# Access Compliance Report

## Public Rights-of-Way

Intersection ID: 28042	Main Street: BRIGHT_ANGEL_CT	Cross Street: OLD_CORRAL_ST	Location: NE
ADA ID: 8FC2D15E2E4D	Ramp Type: PerpDiag	Initial Pass/Fail: Pass	Overall Compliance: No
		Severity Score: 7.5

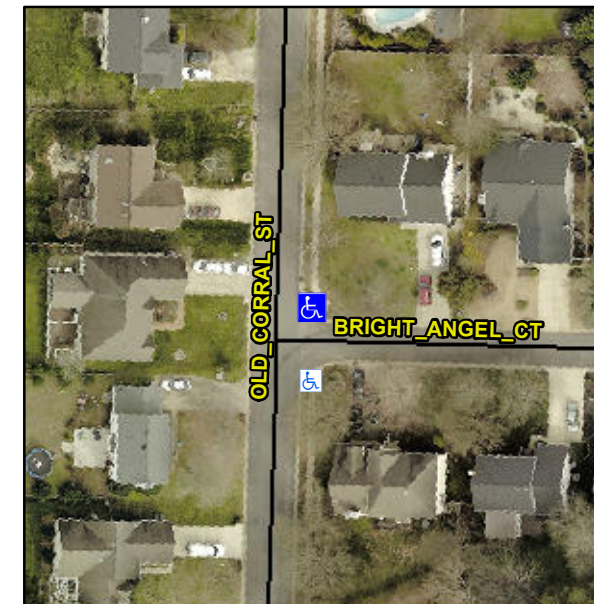
**Not Found, R304.5.3, R305.1.4, R304.5.4**

Compliance	Description	Data	Compliance	Description	Data
N/A	Ramp Length (in)	46.0	Yes	Ramp Slope (%)	6.1
Yes	Ramp Width (in)	56.0	Yes	Ramp XSlope (%)	1.2
N/A	Flare Type LT	Sloped	N/A	Flare Type RT	N/A
N/A	Flare Slope LT (%)	2.0	N/A	Flare Slope RT (%)	4.5
N/A	Flare Traversable LT?	No	N/A	Flare Traversable RT?	No
Yes	Landing Length (in)	49.0	Yes	DWS Provided?	Yes
Yes	Landing Width (in)	56.0	Yes	DWS Contrast?	Yes
Yes	Landing Slope (%)	1.2	Yes	DWS Length (in)	24.0
No	Landing X Slope (%)	3.5	No	DWS Full Width?	No
N/A	Landing Curb? (Y/N)	No	Yes	DWS Offset (in)	1.0
N/A	Shared Landing?	No			
Yes	Gutter Ponding?	No	No	Gutter Slope (%)	6.8
Yes	Gutter Lip Ht (in)	0.0	Yes	Gutter X Slope (%)	2.0
N/A	Painted X Walk1?	No	N/A	Painted X Walk2?	No
	X Walk 1 Direction	To W		X Walk 2 Direction	To SW
N/A	X Walk 1 Width (in)	N/A	N/A	X Walk 2 Width (in)	N/A
	X Walk 1 Slope (%)	3.4		X Walk 2 Slope (%)	0.1
	X Walk 1 X Slope (%)	1.0		X Walk 2 X Slope (%)	0.6

**Remove & Replace Curb Ramp With Two New Directional Ramps or Equivalent. Remove & Replace Gutter.**
